**CITY OF SAN ANTONIO  
PUBLIC WORKS DEPARTMENT  
CITY COUNCIL AGENDA MEMORANDUM**

SUBJECT: Claremont, Eleanor, Natalen, Phase III, Field Alteration Number 1

CITY OF SAN ANTONIO  
DEPARTMENT OF PUBLIC WORKS  
FIELD ALTERATION REQUEST

**CLAREMONT, ELEANOR, NATALEN, PHASE III**

## MACHINE LAID CURB

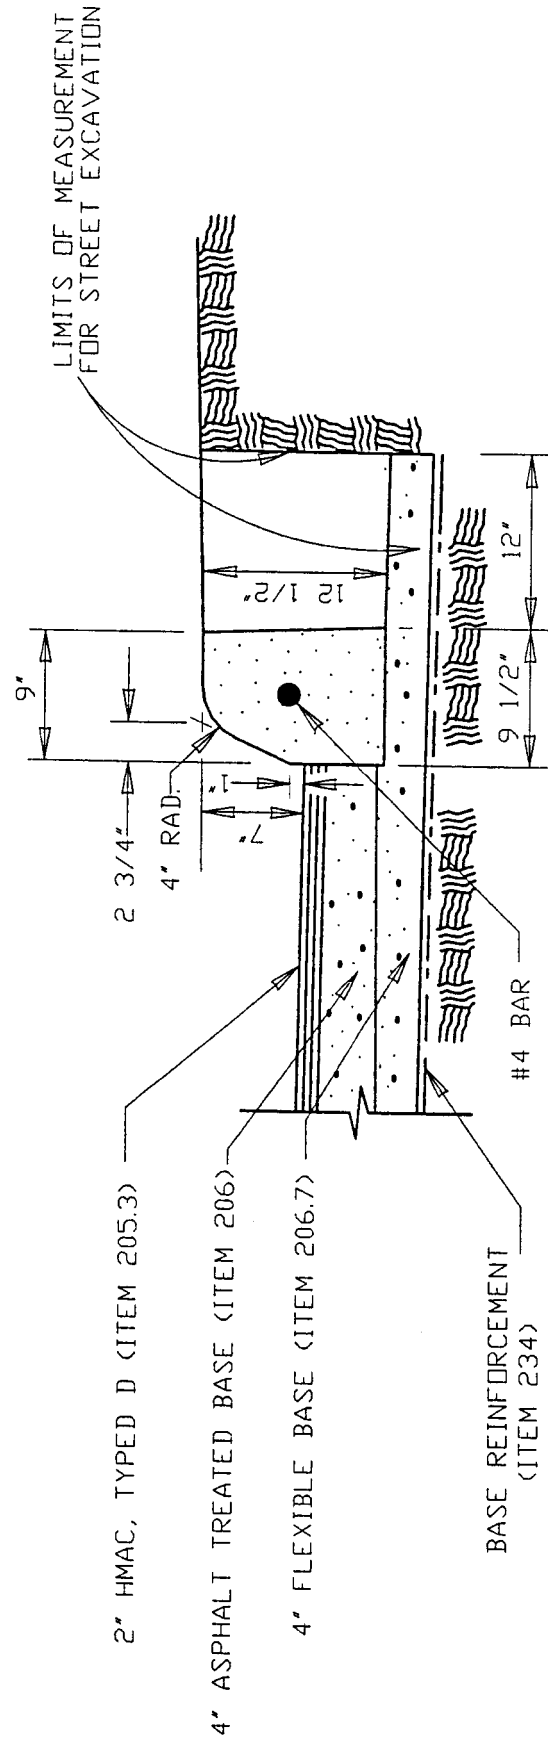
**MODIFY THE STREET SECTION TO 2" HMAC TYPE "D", ITEM 205.3, OVER 4" ASPHALT TREATED BASE, ITEM 206 OVER 4" FLEXIBLE BASE, ITEM 200.7 OVER BASE REINFORCEMENT, ITEM 234. MODIFY THE CURB SECTION TO 12 1/2" HIGH WITH NO 4 REINFORCING BARS AS SHOWN ON ATTACHED DETAIL. SEE ATTACHED SHEET FOR DETAILED COST BREAKOUT.**

**PROVIDE STRUCTURAL STREET SECTION FOR INCREASE IN TRAFFIC COUNT IN PROJECT AREA DUE TO CLOSURE OF NEW BRANUFELS THROUGH FORT SAM HOUSTON**

(WITH REINFORCING STEEL)  
 ITEM 501 ON FLEXIBLE BASE MATERIAL  
 N.T.S.
